ADDENDUM #1 – FEBRUARY 12, 2024

RE: NORTH BAY FIRE STATION
Seismic Upgrade and Addition
Project #21.59

FROM: HGE ARCHITECTS, Inc.
333 South 4th Street
Coos Bay, Oregon 97420
541-269-1166

1 PLUMBING ENLARGED UNDERSLAB PLAN - ALTERNATE BID
1/4" = 1'-0"

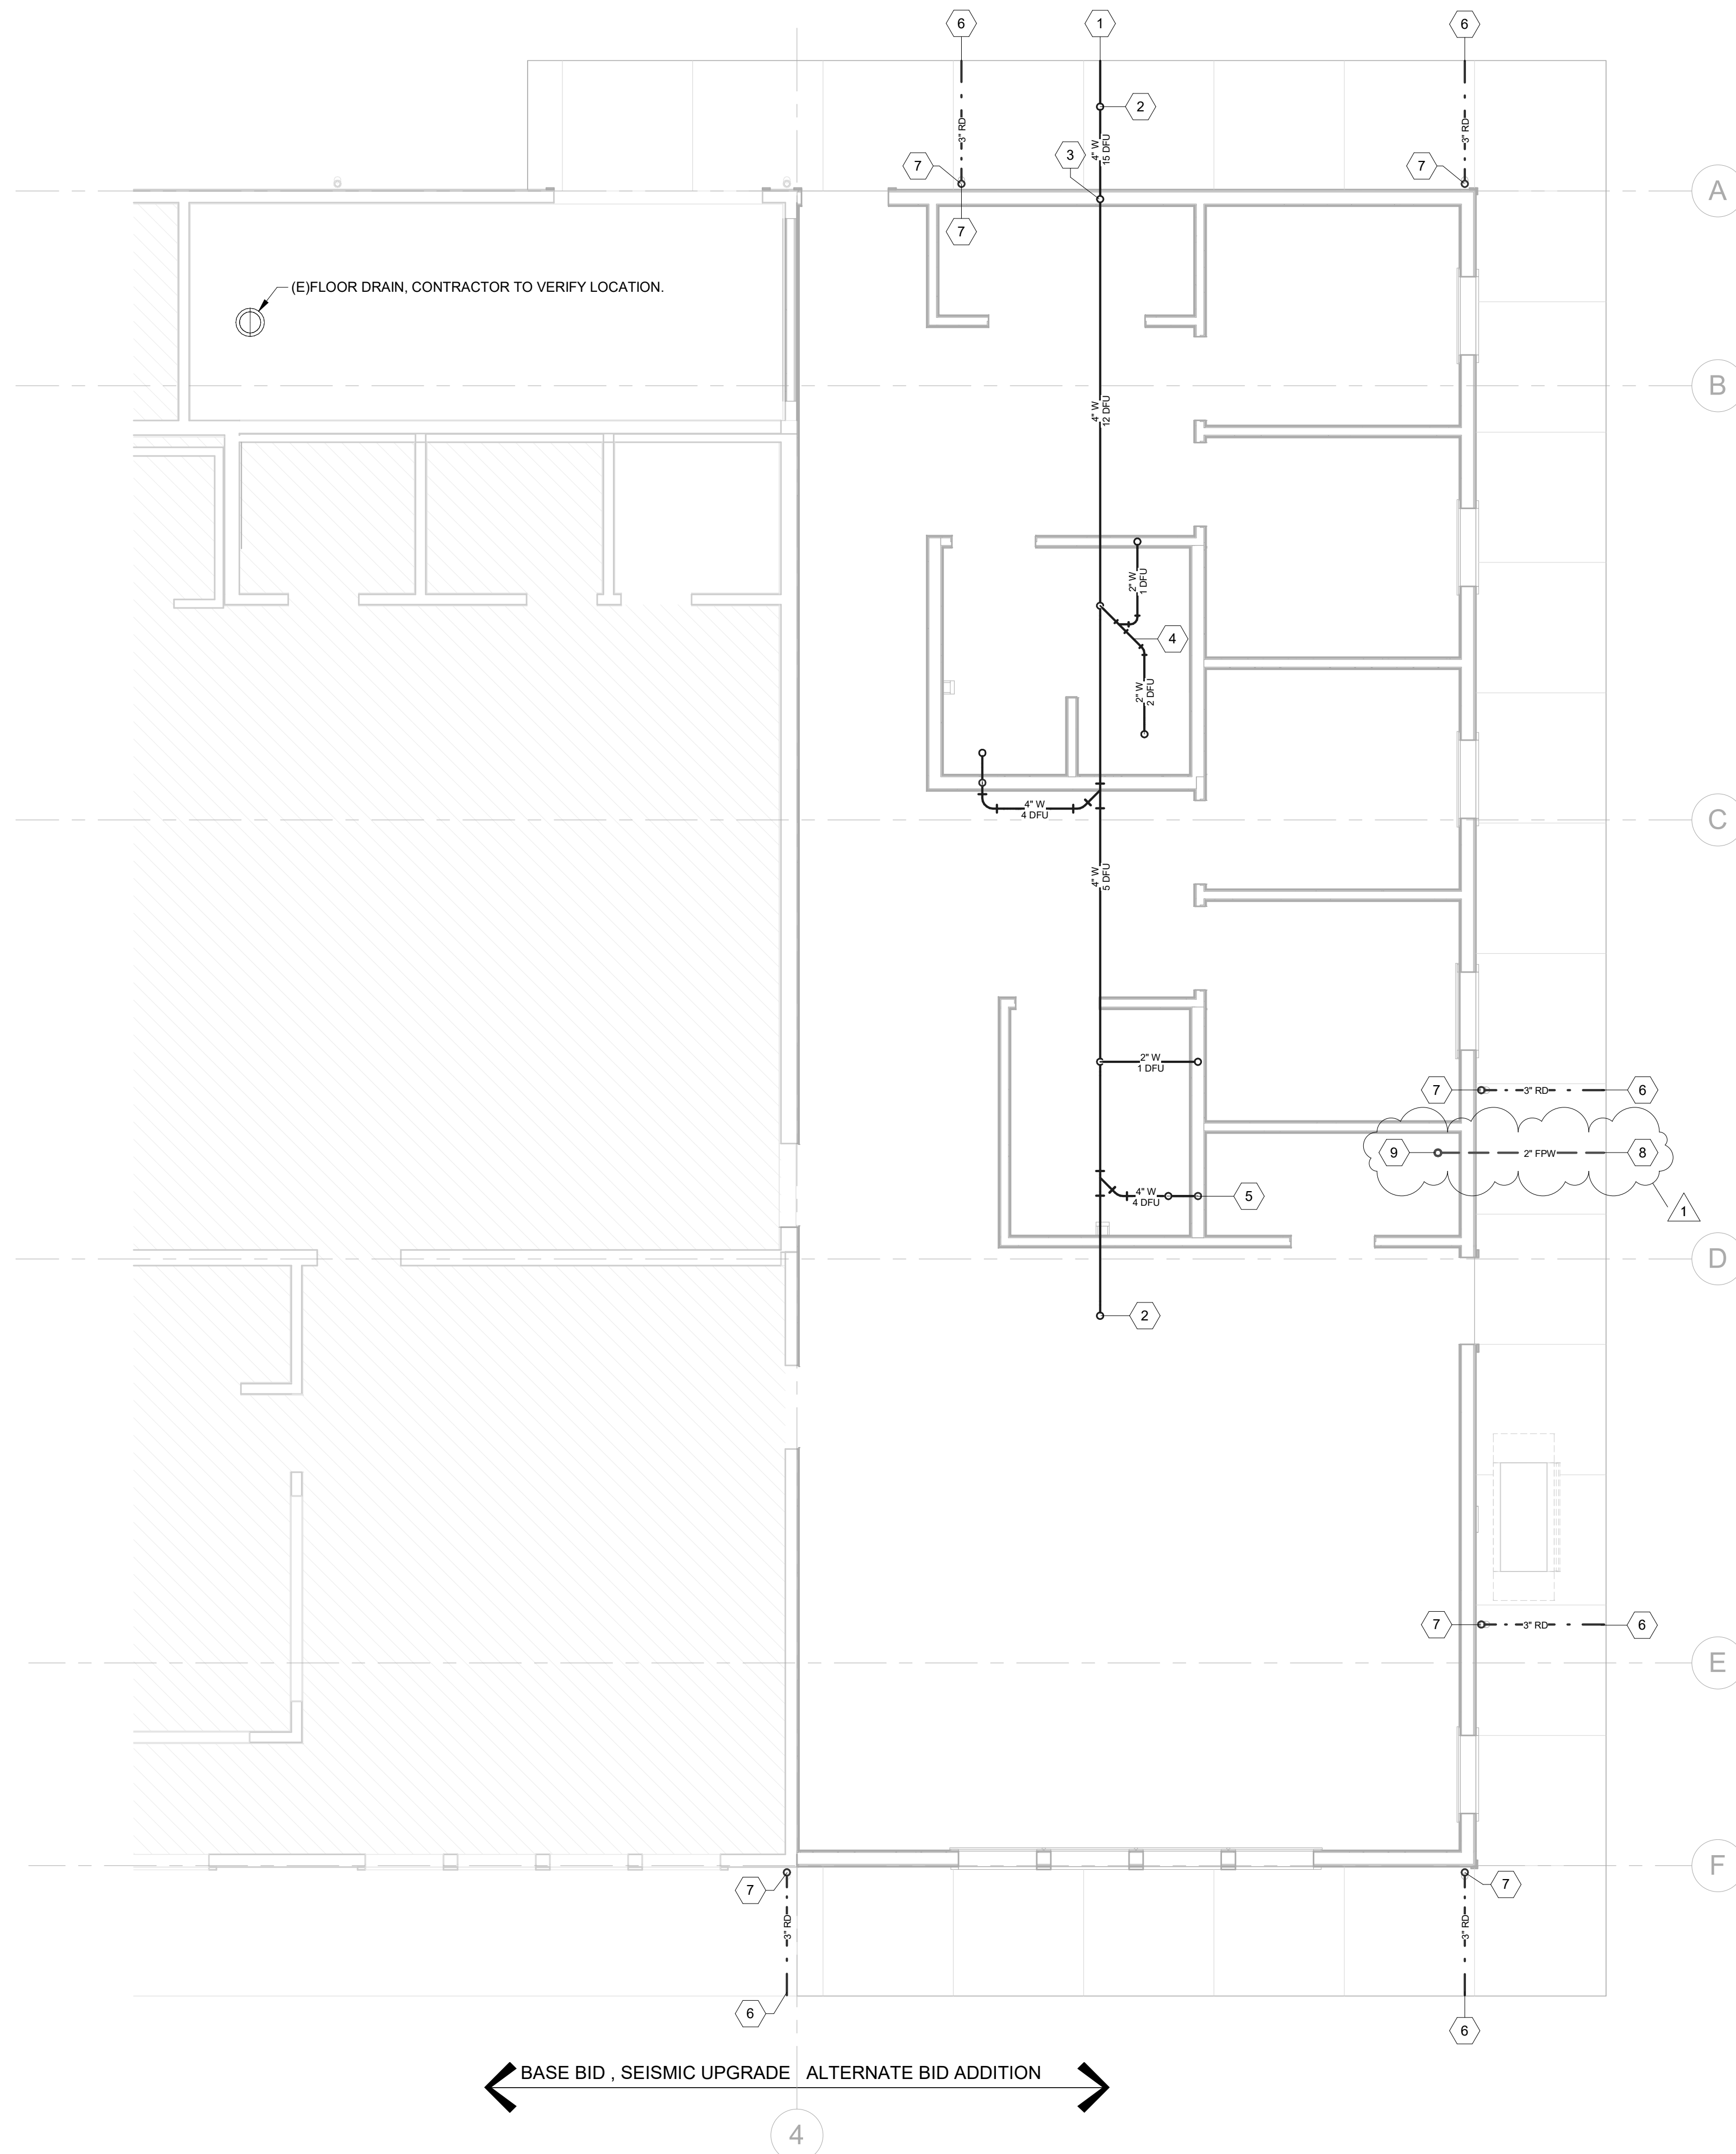
7. **Sheet P2.1 Plumbing Enlarged Underslab Plan:** Sheet attached. Make the following changes –
 - a. Keynotes: ADD keynotes "8. 2" Fire Water Connection, See Civil for Continuation; 9. 2" Fire water up to fire riser, see detail 2/P2.2."

- b. ADD 2" FPW line at Gridline D from exterior to fire riser location.
8. **Sheet P2.2 Plumbing Enlarged Floor Plan:** Sheet attached. Make the following changes –

- 1 4"W, SEE SITE PLAN FOR CONTINUATION.
- 2 WASTE PIPE DOWN FROM CLEANOUT.
- 3 2"W DOWN FROM LEVEL ABOVE.
- 4 WET VENTED PIPE.
- 5 2"V UP TO NEXT LEVEL.
- 6 3"RD, SEE SITE PLAN FOR CONTINUATION.
- 7 3"RD DOWN FROM LEVEL ABOVE. CONNECT TO DOWNSPOUT, SEE 3/P0.1 FOR DETAIL.
- 8 2" FIRE WATER CONNECTION, SEE CIVIL FOR CONTINUATION.
- 9 2" FIRE WATER UP TO FIRE RISER, SEE DETAIL 2/P2.2.

1 PLUMBING ENLARGED FLOOR PLAN - ALTERNATE BID
1/4" = 1'-0"

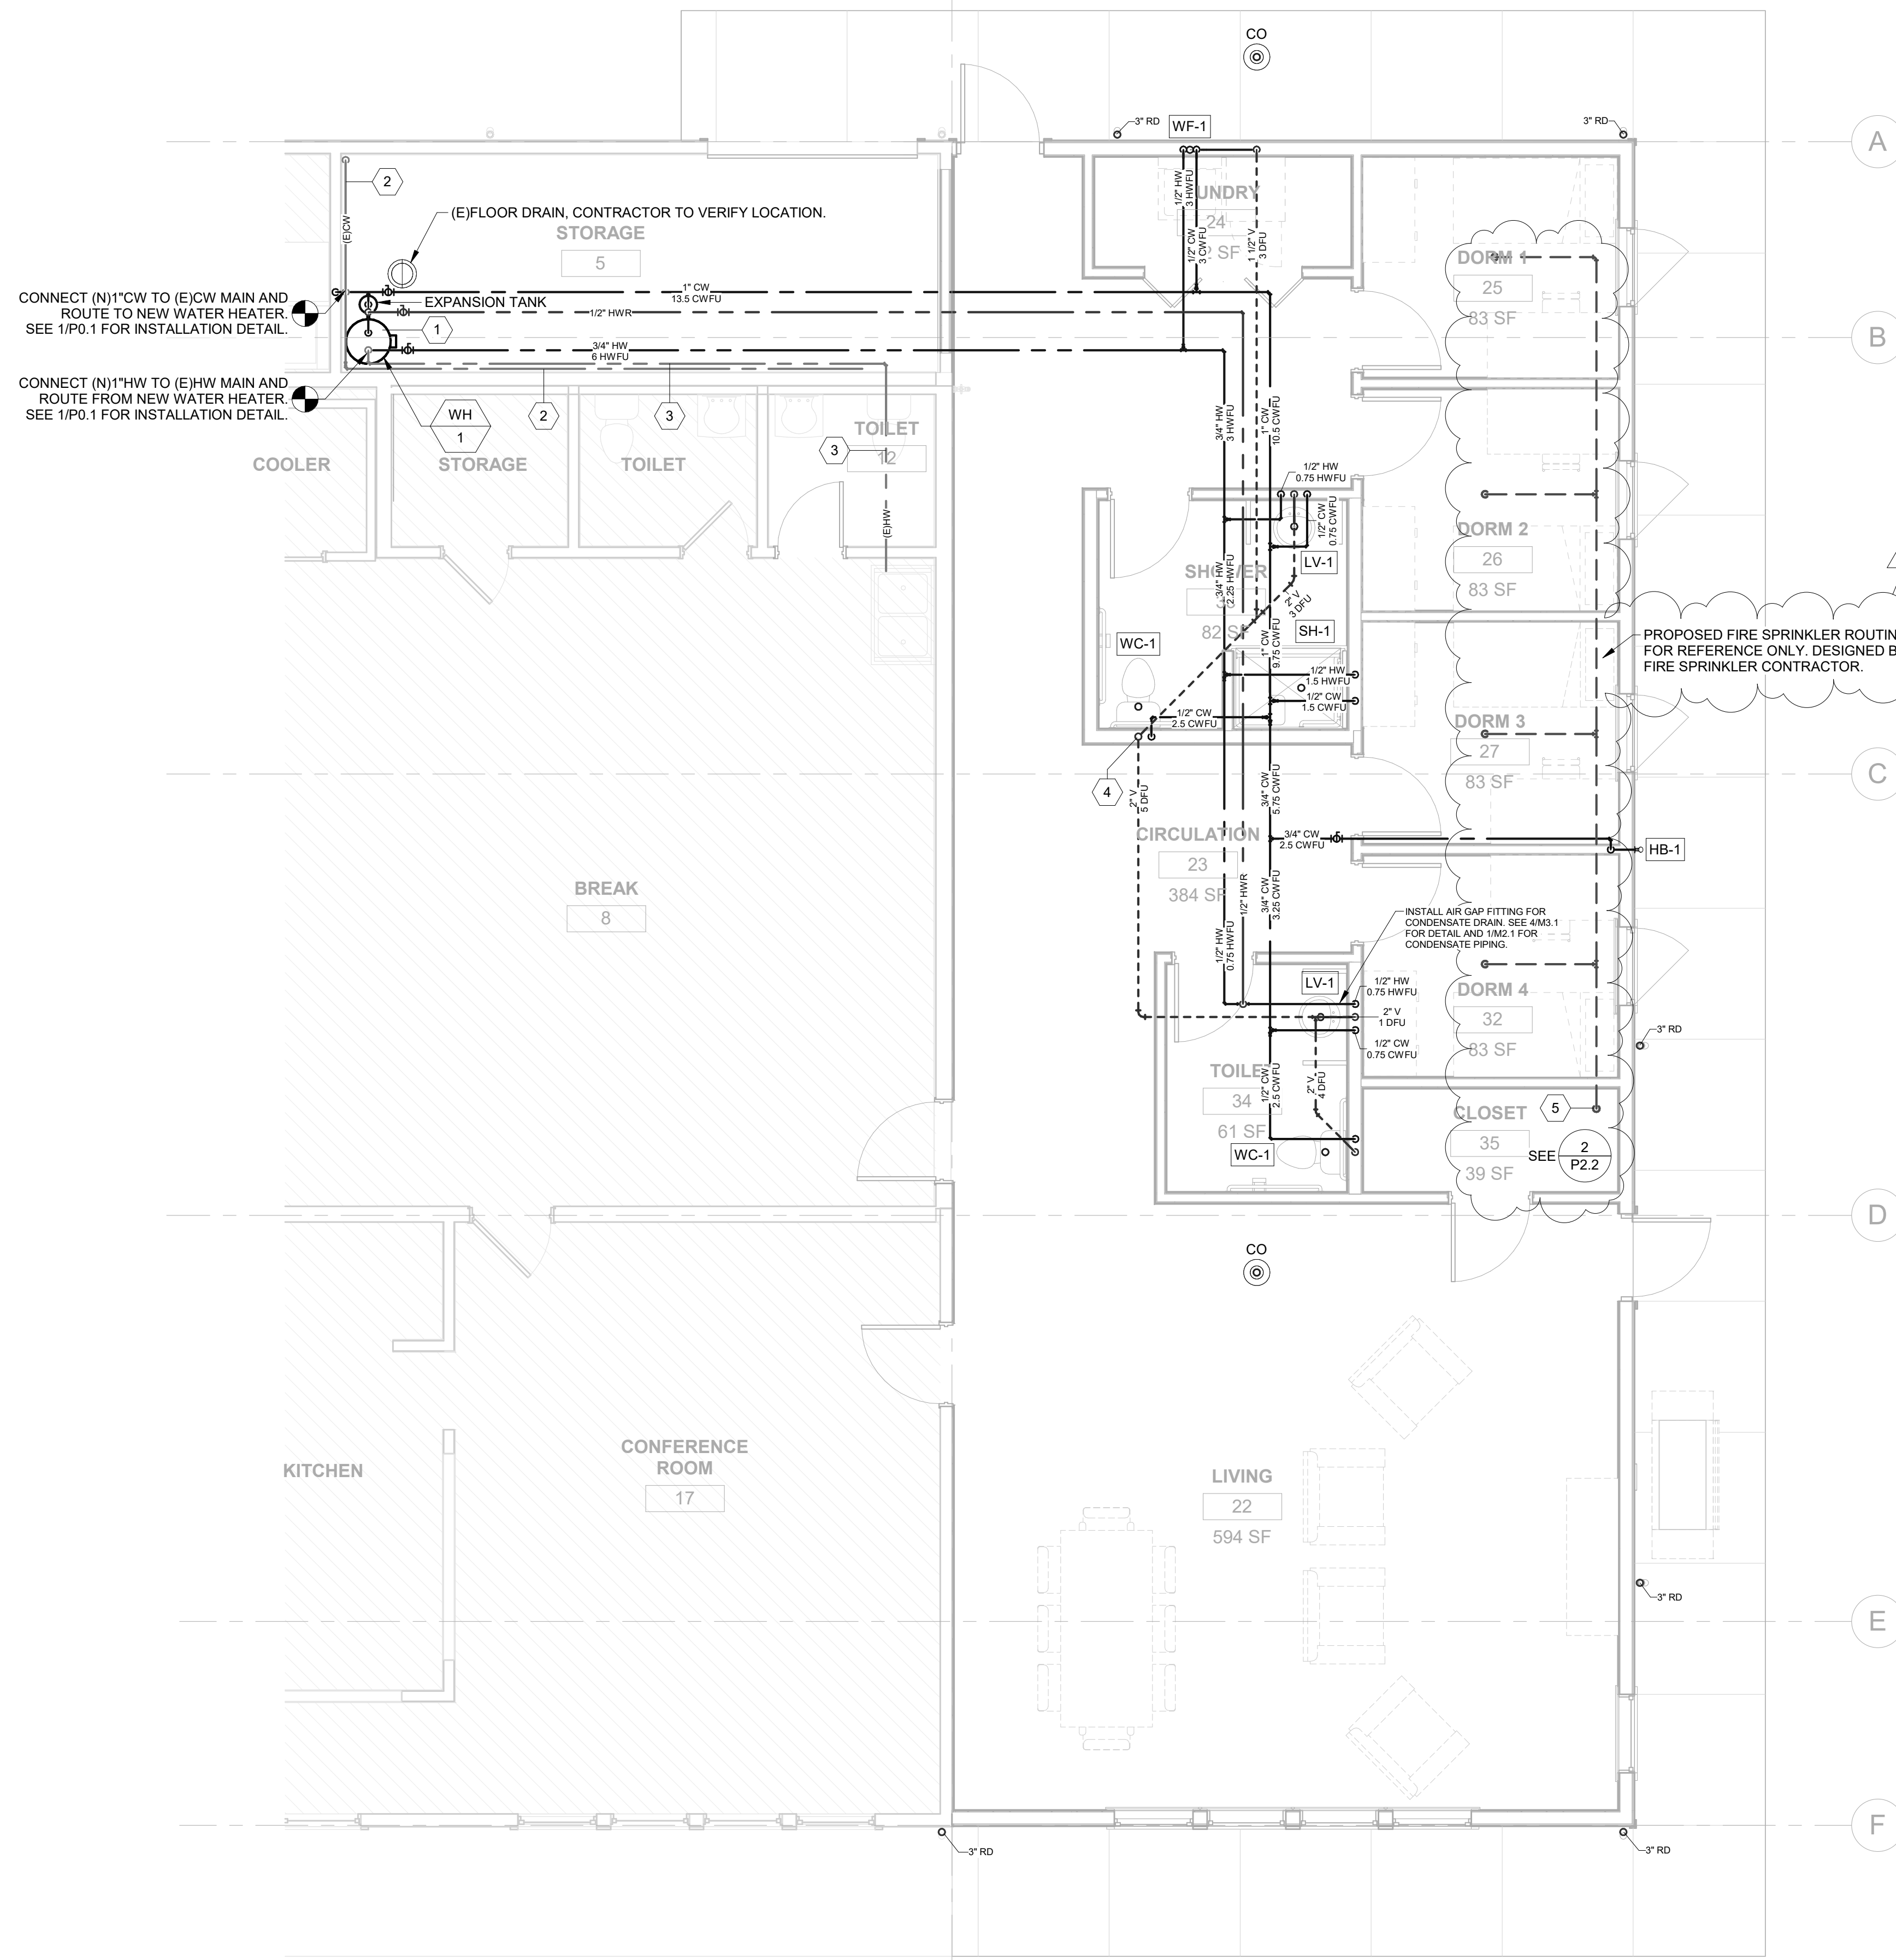
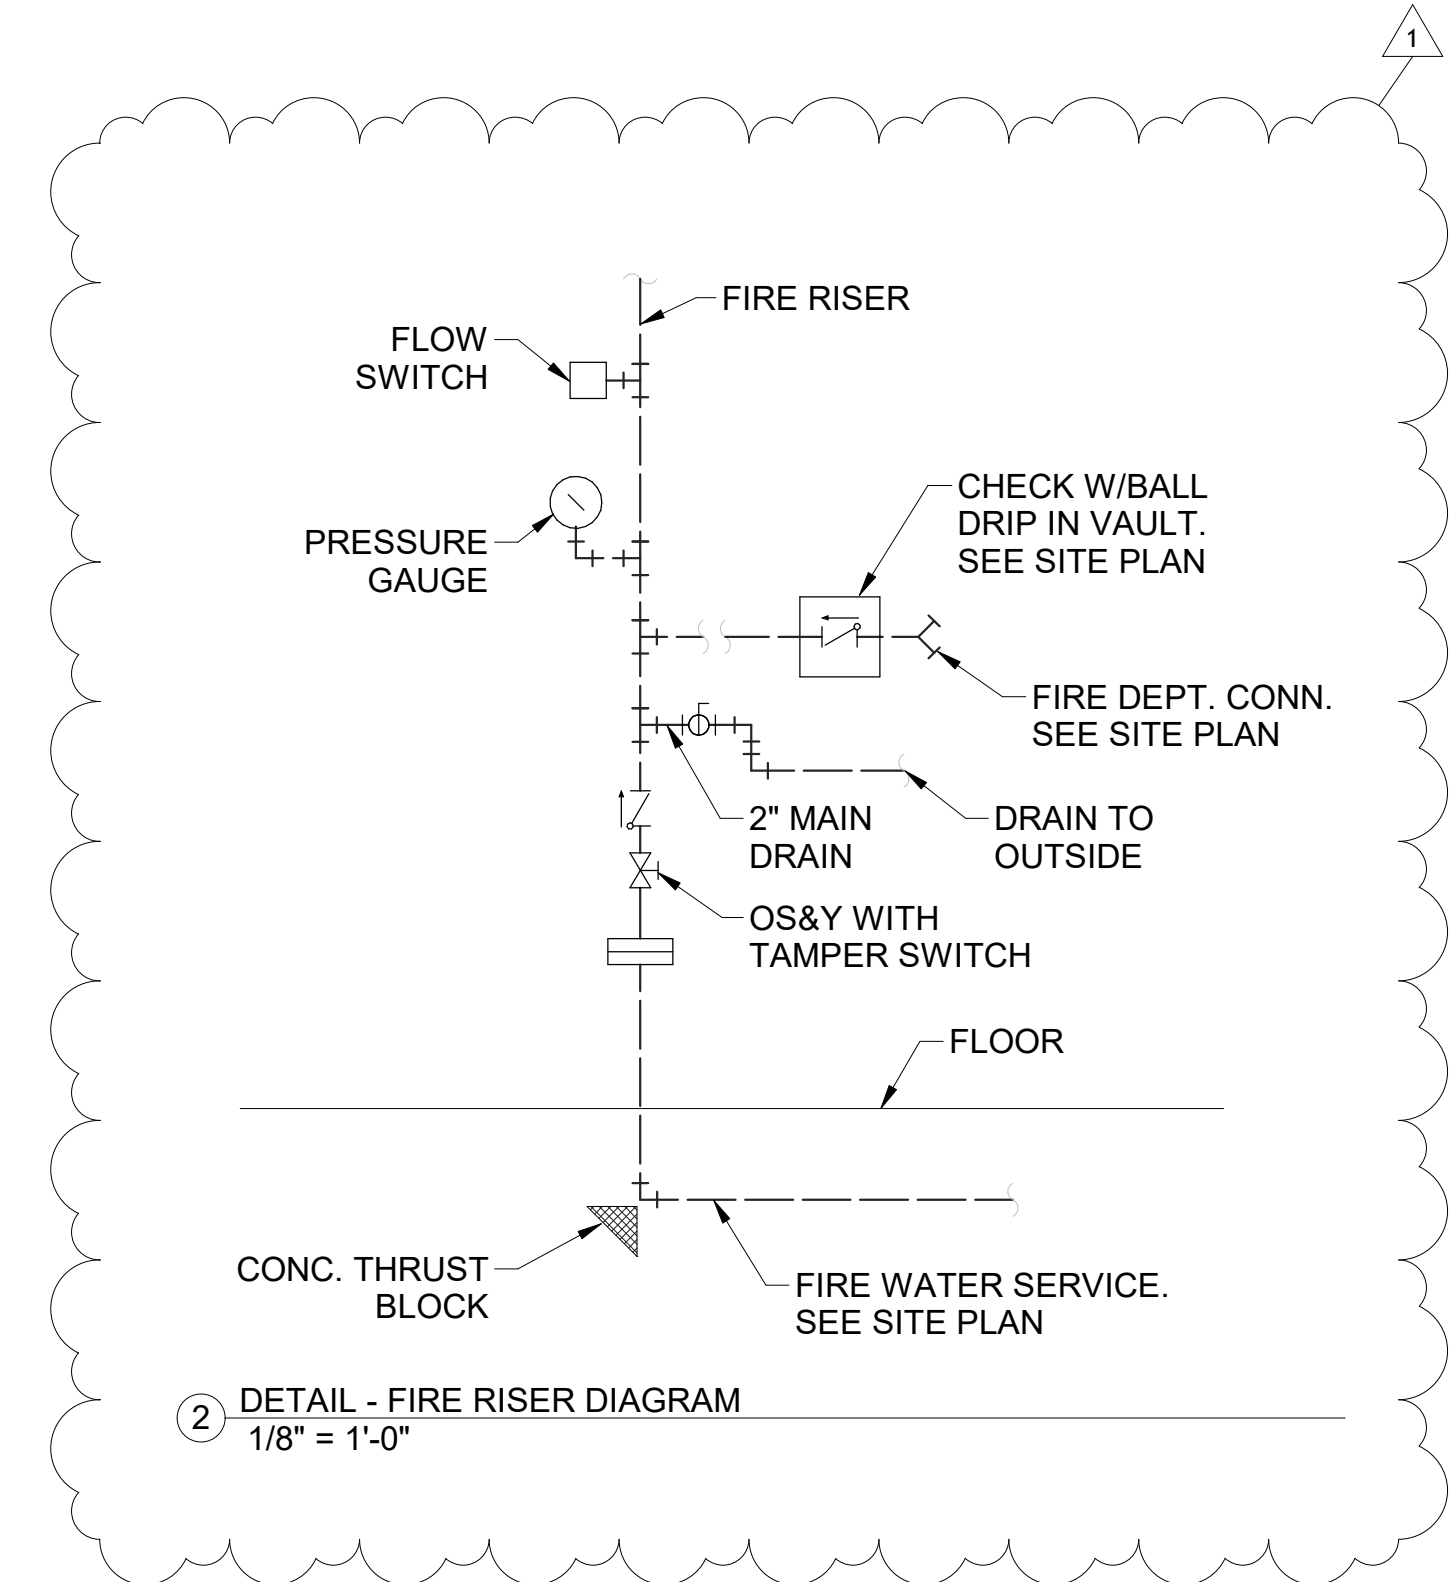
- a. ADD Detail 2/P2.2 – Fire Riser Diagram
 - b. ADD fire sprinkler piping as shown and noted.
9. **Sheet E2.2 Alternate Bid Power & Lighting, Sheet Notes:** ADD note "Add flow and tamper monitoring devices at the fire riser and connect to the existing fire alarm panel.

- 1 NEW WH-1 & RCP-1, SEE 1/P.0.1 FOR DETAIL.
- 2 ASSUMED LOCATION OF (E) CW MAIN. CONTRACTOR TO VERIFY LOCATION.
- 3 ASSUMED LOCATION OF (E) HW MAIN. CONTRACTOR TO VERIFY LOCATION.
- 4 4" VTR.
- 5 2" FIRE RISER, SEE DETAIL 2/P.2.
